BALTIMORE COUNTY PUBLIC SCHOOLS

ADDENDUM NUMBER 2

BID NAME: NEW SCHOOL CONSTRUCTION LANSDOWNE ELEMENTARY SCHOOL
DEMOLITION OF LANSDOWNE ELEMENTARY SCHOOL

BID NUMBER: **MBU-516-17**

SK-E-15

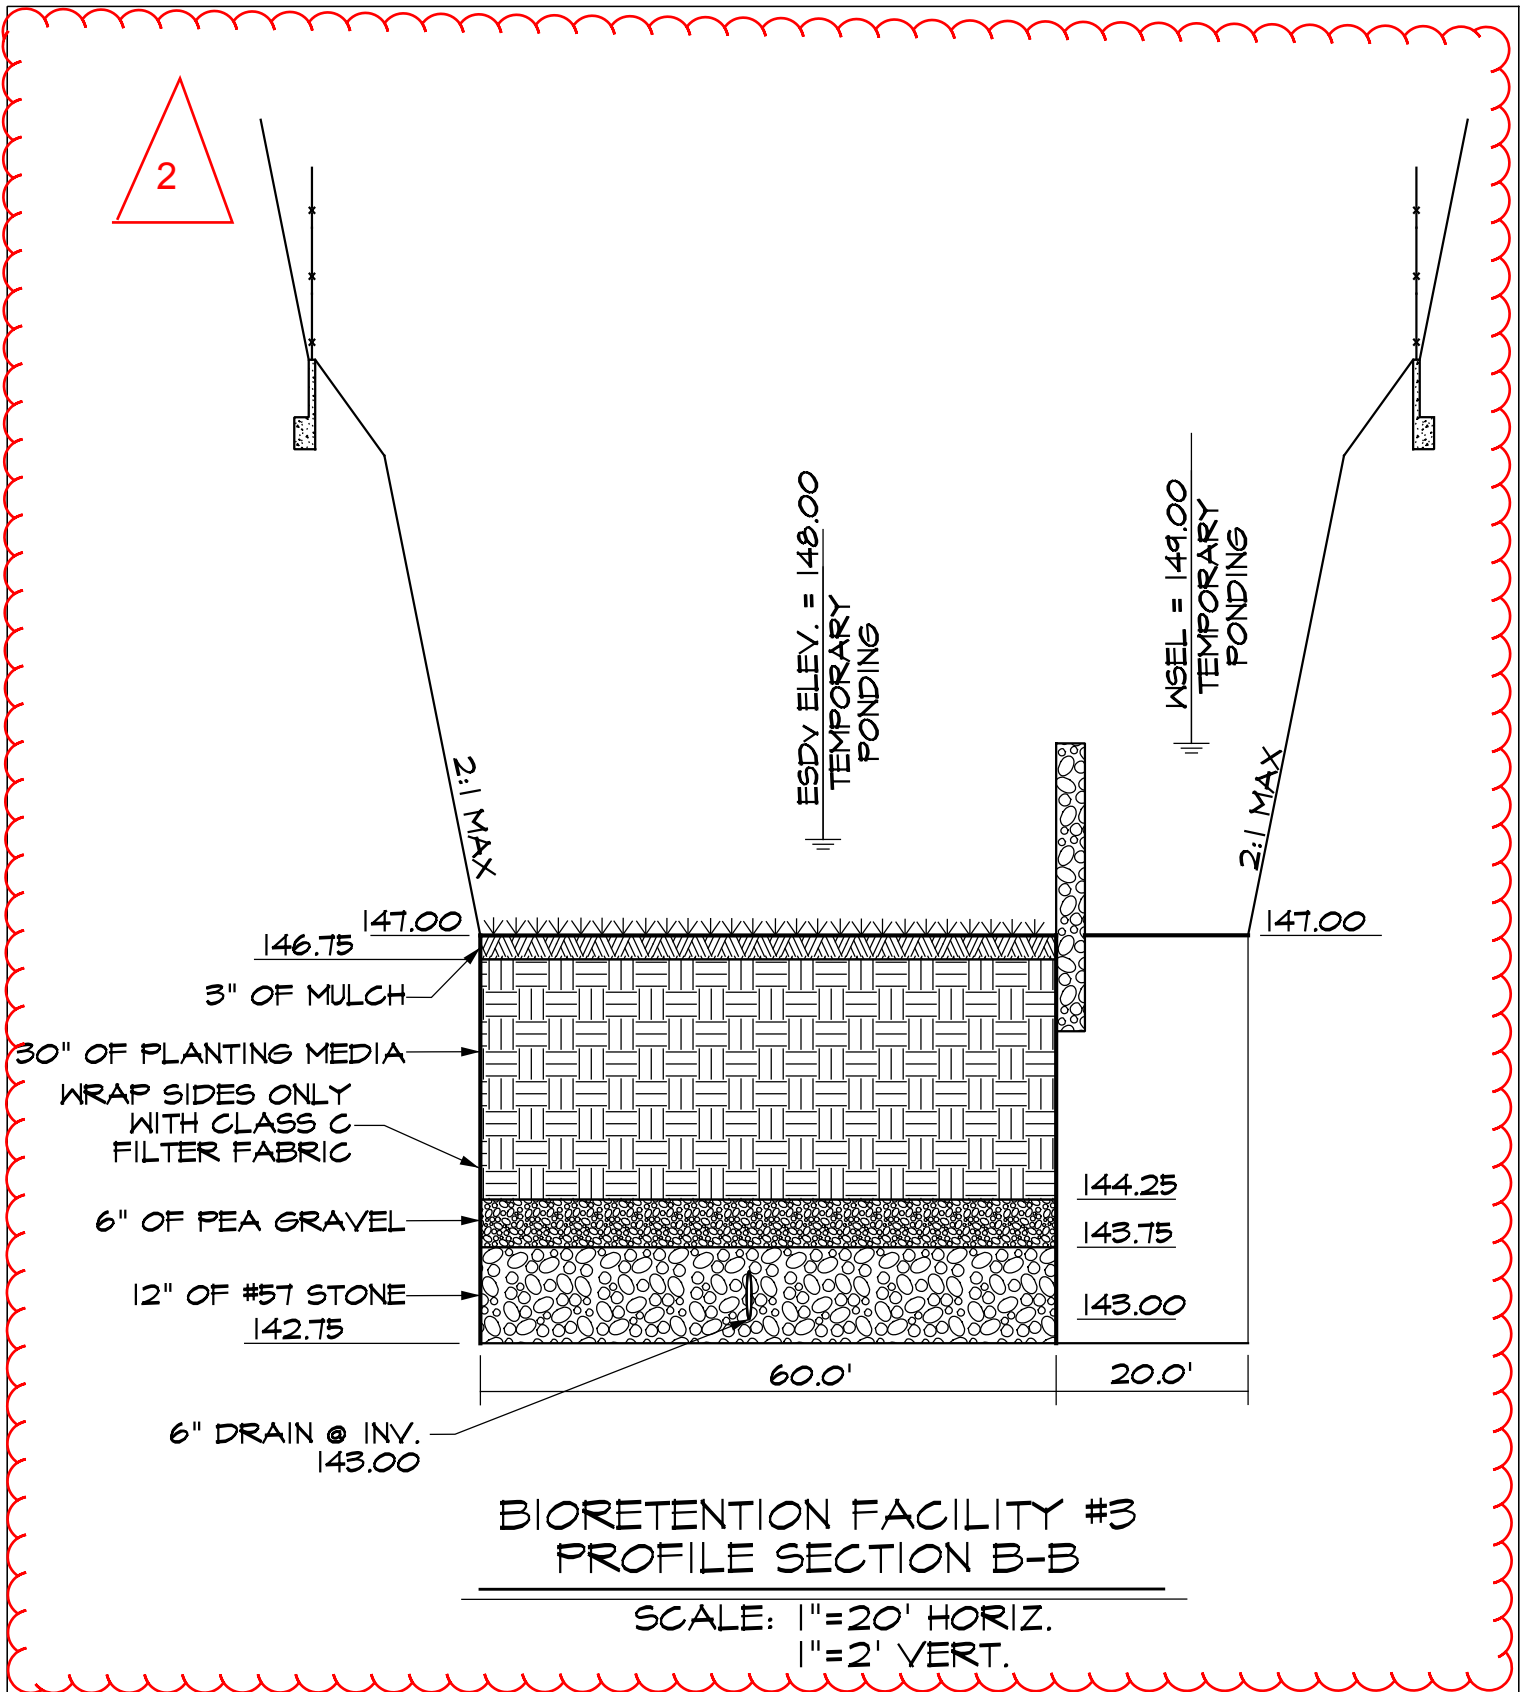
ADD: Electrical connections for projection screen as indicated on sketch SK-E-

SK - C - 19

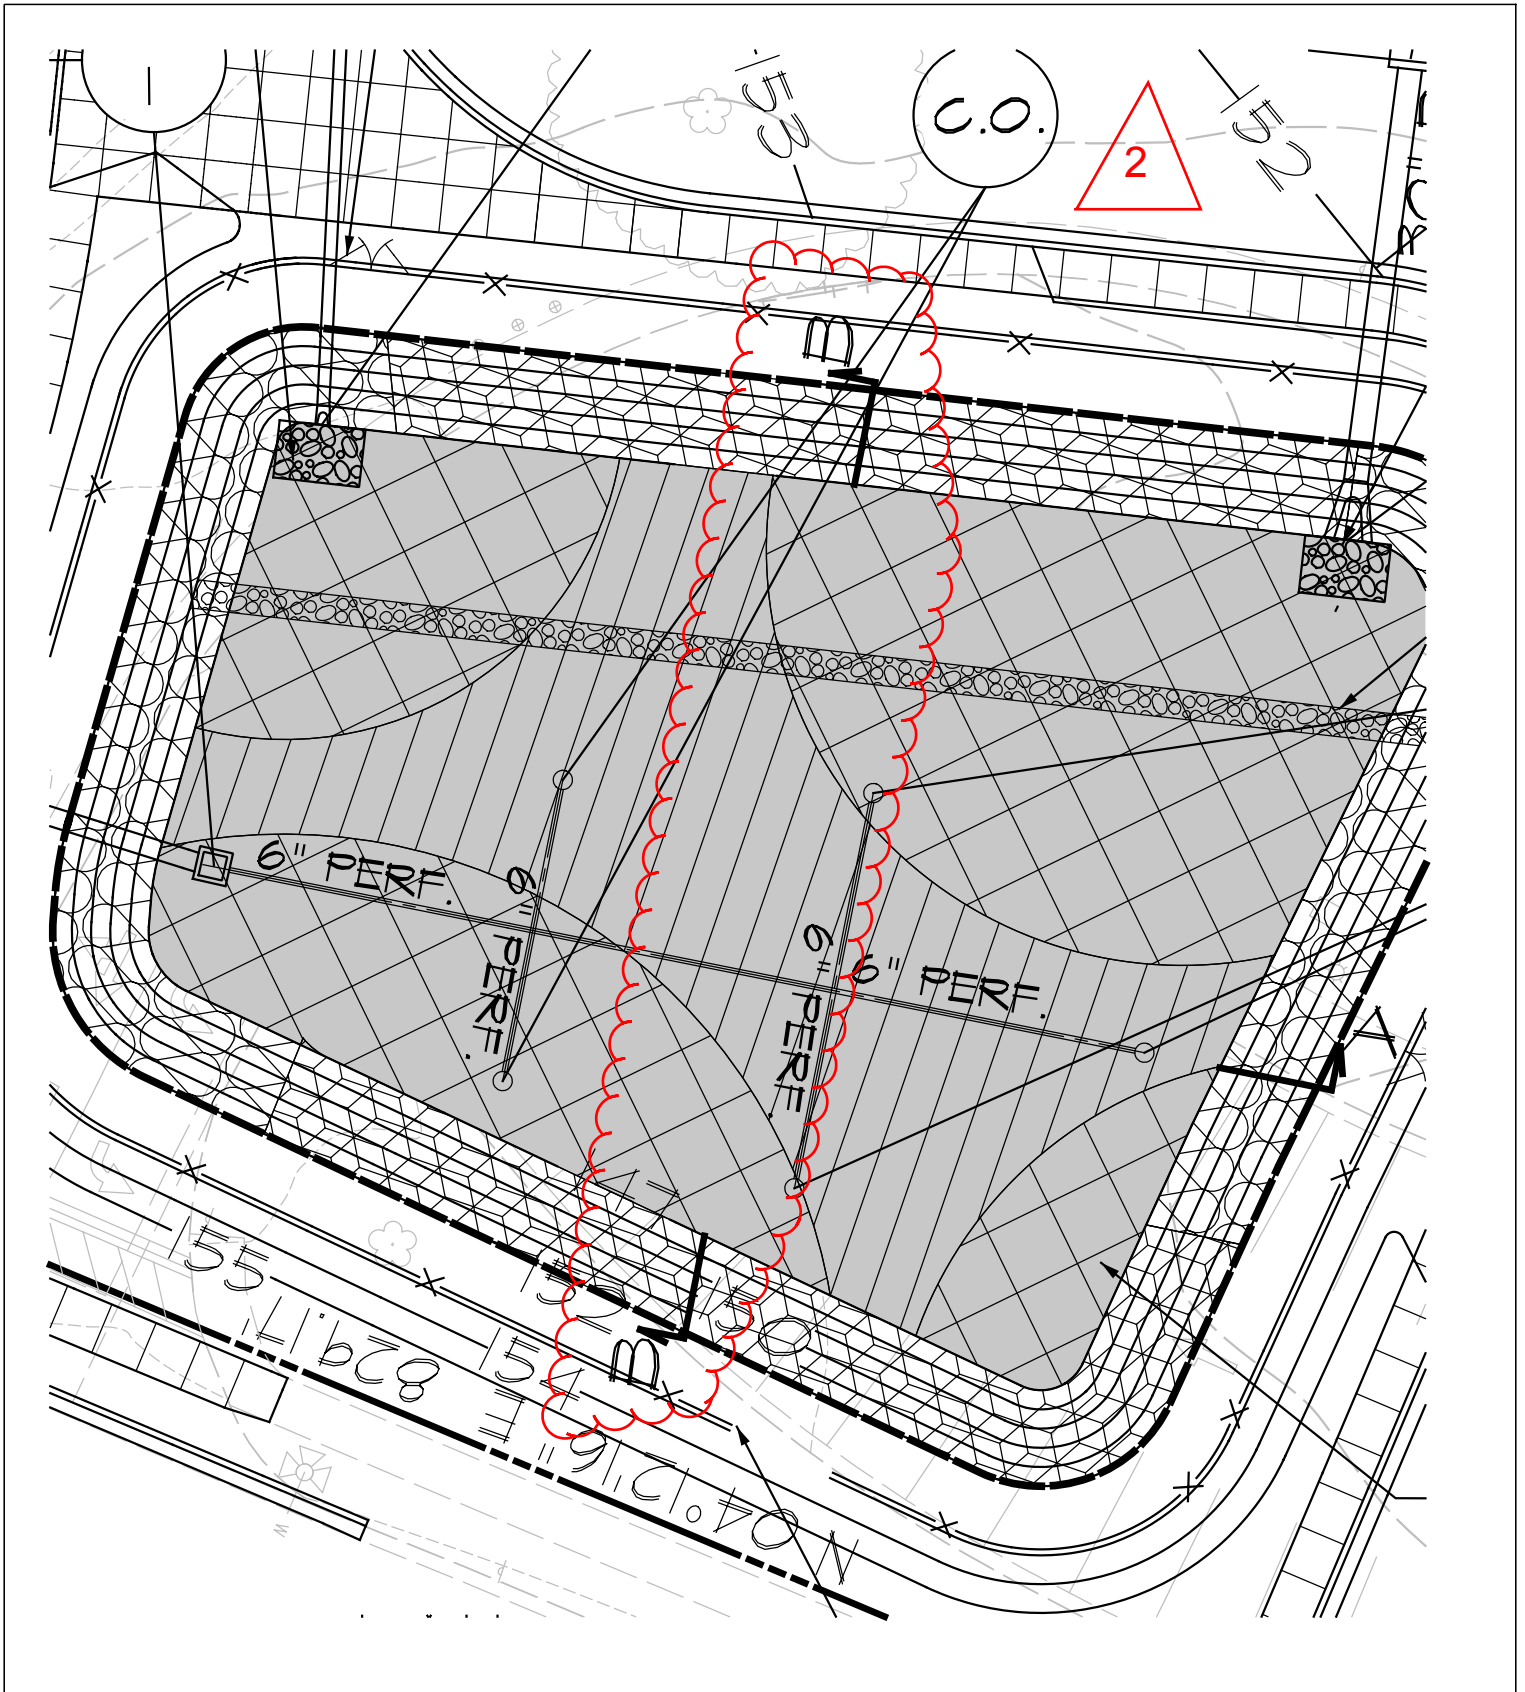
- 3.4. SHEET C-7.4, FINAL STORMWATER MANAGEMENT DETAILS
ADD: Section B-B and profile. See attached sketch SK-19 and 19A.
- 3.5. SHEET C-8.1, LANDSCAPE PLAN
REVISE: Weave chainlink fence size to 2" for Soft Play and 1" for SWM Facilities on all Chainlink Fence Details.

SK- C -21

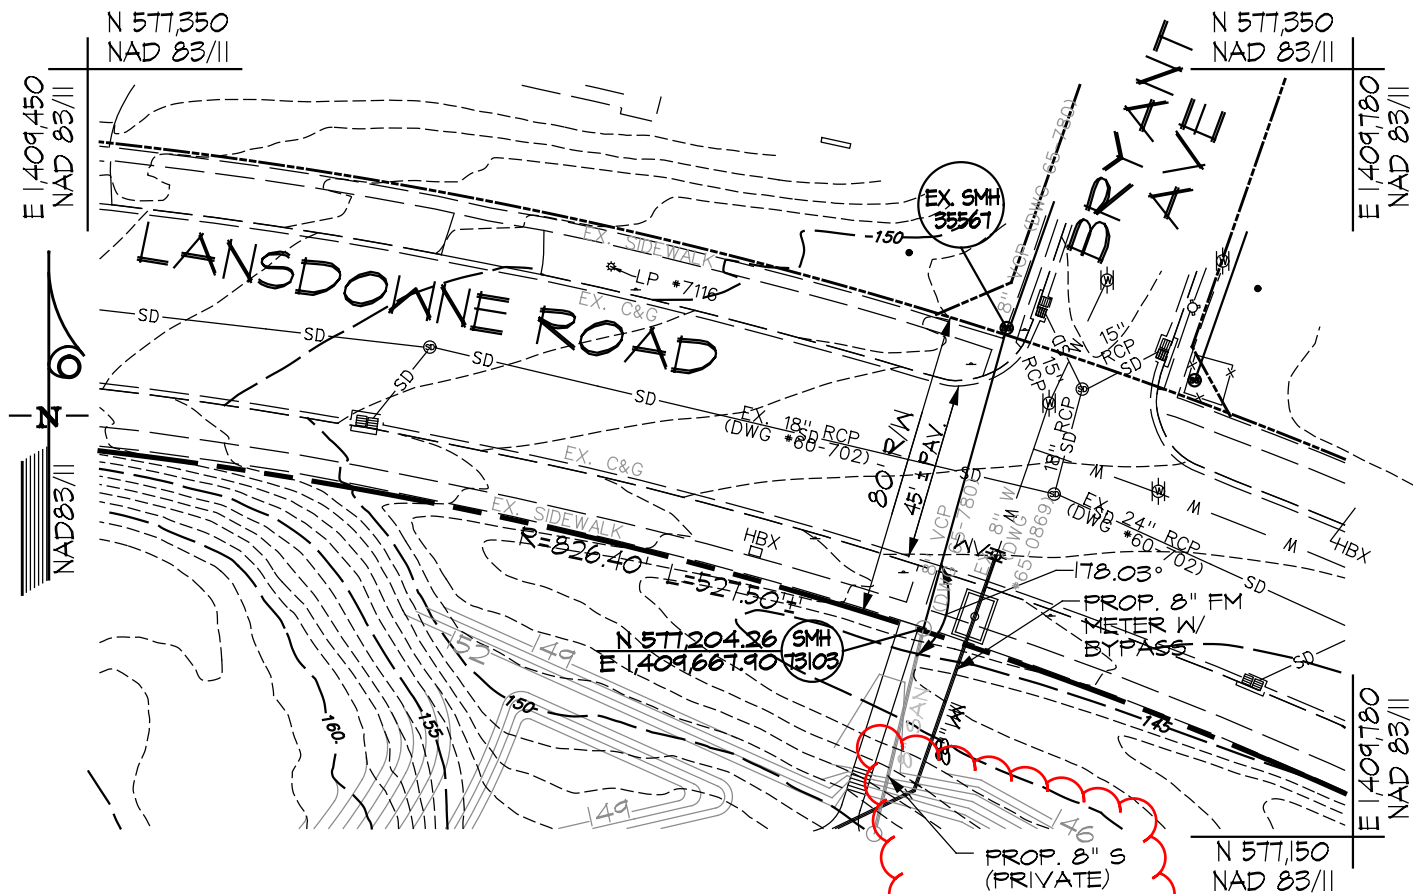
- 3.8. SHEET C-10.2, PUBLIC SANITARY SEWER AND RIGHT-OF-WAY PLAN
ADD: Sewer callouts in the Vicinity Map. See attached sketch SK-21.
REVISE: (by others) callout to (private) on the Proposed 8" Sanitary Sewer Connection Plan. See attached sketch SK-21A.

SK- C -23

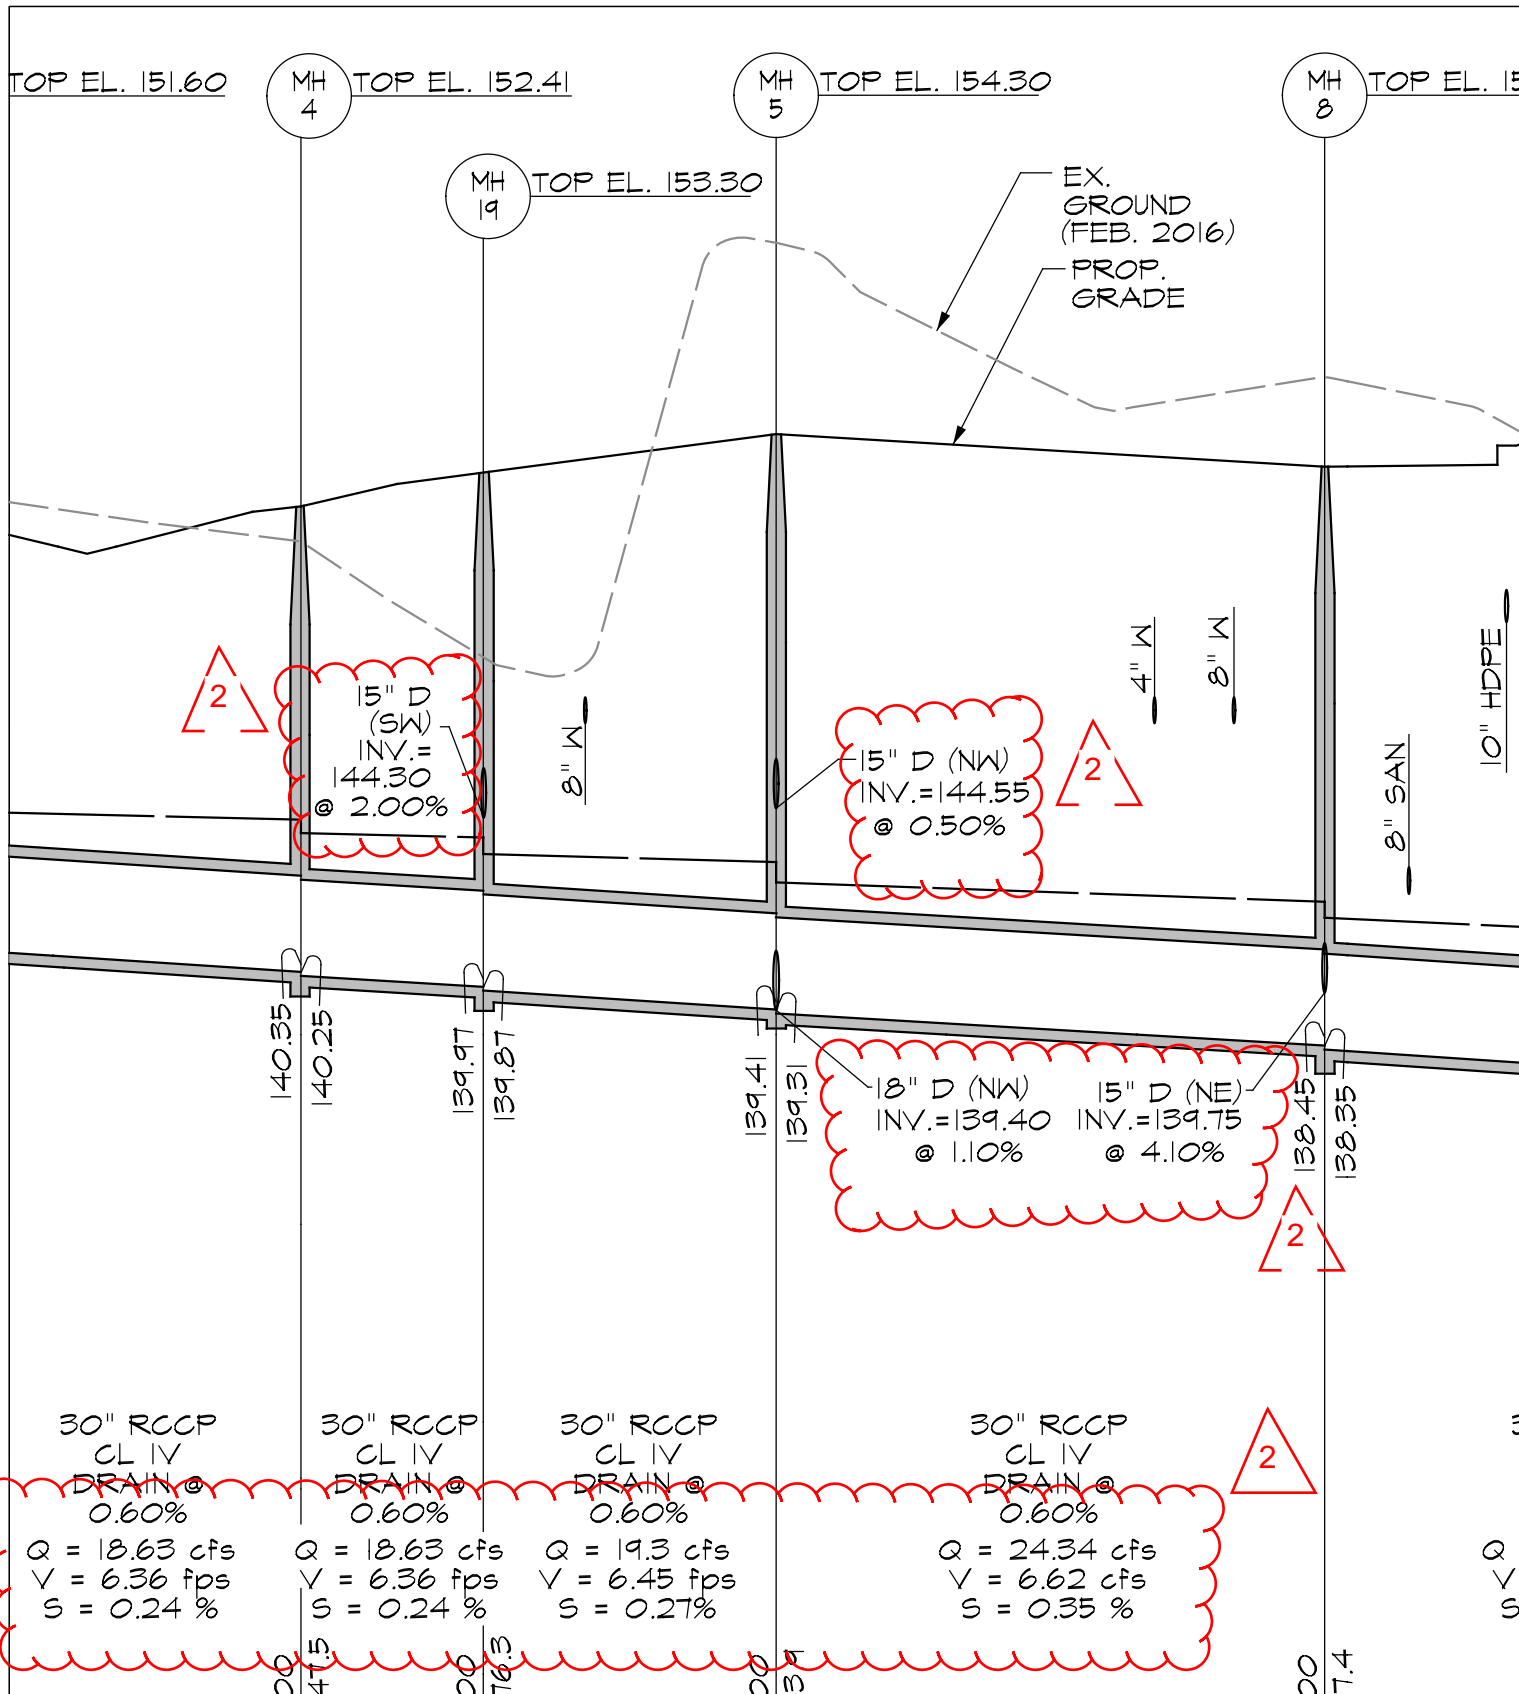
- 3.9. SHEET C-10.3, PUBLIC STORM DRAIN PLAN - 1
REVISE: Storm drain design data. See attached sketch SK-C-22.
- 3.10. SHEET C-10.4, PUBLIC STORM DRAIN PLAN – 2
REVISE: Manhole Schedule. See attached sketch SK-C-23.
ADD: Manhole 18 label. See attached sketch SK-C-23A.
REVISE: Pipe Q, V, S on the profile. See attached sketches SK-C-23A to 23D.
ADD: Pipe slope to connecting storm drain pipes on the profile. See attached sketch SK-C-23A to 23D.
